The following is a summary of the SBAB Working Group's comments on the DRAFT Right-of-Way Improvement Manual. Specific comments can be found in the attached pdf, which has been reduced to the pages which this group focused on, specifically.

#### pp. 203-261 BIKE FACILITY DESIGN STANDARDS

Advisory Bike Lanes (graphic below):

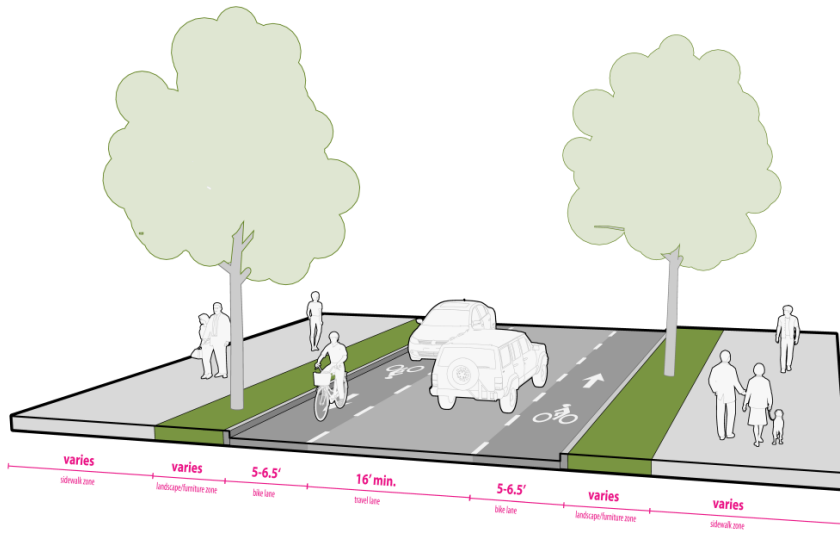
Advisory Bike Lanes are not recommended – Sharrows should be used where there is insufficient ROW space for a buffered or protected bike lane. This typology (while listed in the Bicycle Master Plan) does not convey sufficient caution to drivers and instead encourages them to borrow space from people in separately marked bike lanes. Preference should be given to designs that encourage the opposite behavior of *drivers yielding to bikes*.
